Historic Preservation Design Review

HP-11-18, 13 N. Main St. (City)

Request: Design Review for proposed rear exterior renovations

Gutter Supply's ***Heath***
front view (top) and
side view (bottom)

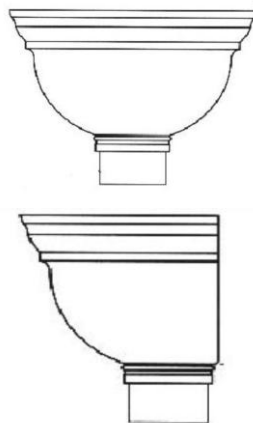
Two of the existing leaderheads (conductor heads that collect water from the roof through opening pipe conduits in the rear wall) and downspouts are painted to match the rest of the rear façade, and one has a brushed plain metal finish. The leaderheads are to be replaced with aluminum collectors by Gutter Supply Co. (Lake Bluff, IL) model “Heath,” (15” x 9” x 10”) with round aluminum downspouts to match.

#13) UPPER FACADE WINDOWS SHOULD RETAIN ORIGINAL DIMENSIONS AND DETAILS

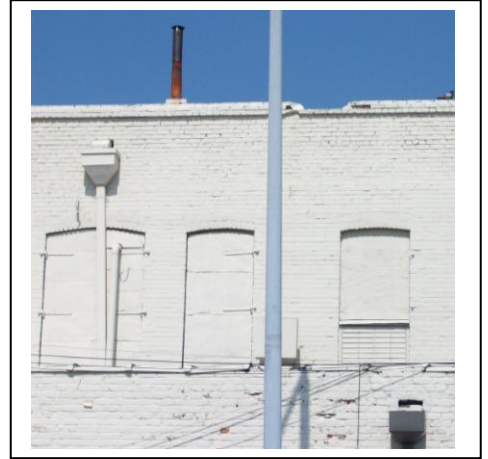
The replacement windows are proposed to be two-over-two because this is the style on the adjacent portion of the building (New York High Style).
